APPLICATION NO.		FILING DATE	FIRST NAMED INVENTOR	ATTORNEY DOCKET NO.	CONFIRMATION NO.	
10/809,137	•,	03/25/2004	Rong-Faa Wu	LELI 3512	7726	
321	7590	11/29/2005		EXAMINER		
	ER POW	ERS TAN SQUARE	· LUGO, CARLOS			
16TH FLO		IMITOQUARE	ART UNIT	PAPER NUMBER		
ST LOUI	S, MO 63	3102	3676			
				DATE MAILED: 11/29/2005

Applicat	Application No. Applicant(s)						
Office Action Summary			37	WU ET AL.					
			r	Art Unit					
Å,		Carlos Lu		3676					
Period fo	The MAILING DATE of this communi or Reply	cation appears on th	e cover sheet with the c	orrespondence ad	ldress				
A SHORTENED STATUTORY PERIOD FOR REPLY IS SET TO EXPIRE 3 MONTH(S) OR THIRTY (30) DAYS, WHICHEVER IS LONGER, FROM THE MAILING DATE OF THIS COMMUNICATION. - Extensions of time may be available under the provisions of 37 CFR 1.136(a). In no event, however, may a reply be timely filed after SIX (6) MONTHS from the mailing date of this communication. - If NO period for reply is specified above, the maximum statutory period will apply and will expire SIX (6) MONTHS from the mailing date of this communication. - Failure to reply within the set or extended period for reply will, by statute, cause the application to become ABA

Attachment #1

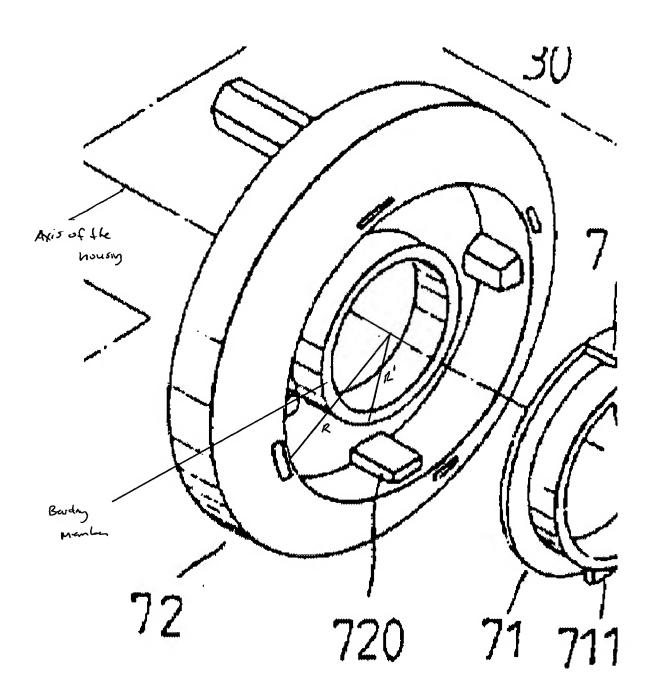
Regarding claim 1, Hu discloses a reinforced apparatus comprising a housing (72) provided with a recess formed thereon and at least one protruding portion (720) disposed at a predetermined position of the housing; and a rotary member including a first side plate (71), a second side plate (74) and a coiled spring (73) disposed between the first side plate and the second side plate. The coiled spring has a leg for abutting against the at least one protruding portion of the housing.

Hu further discloses a bending member, that when the rotary member and the coil spring are disposed inside the recess of the housing, the bending member is adapted to engage the second side plate in order to keep the rotary member positioned within the recess and operated by an external force.

The bending member will be positioned at a distance with respect to an axis of the housing smaller than a distance from the axis of the housing to the outer edge of the second side plate (see attachment #1).
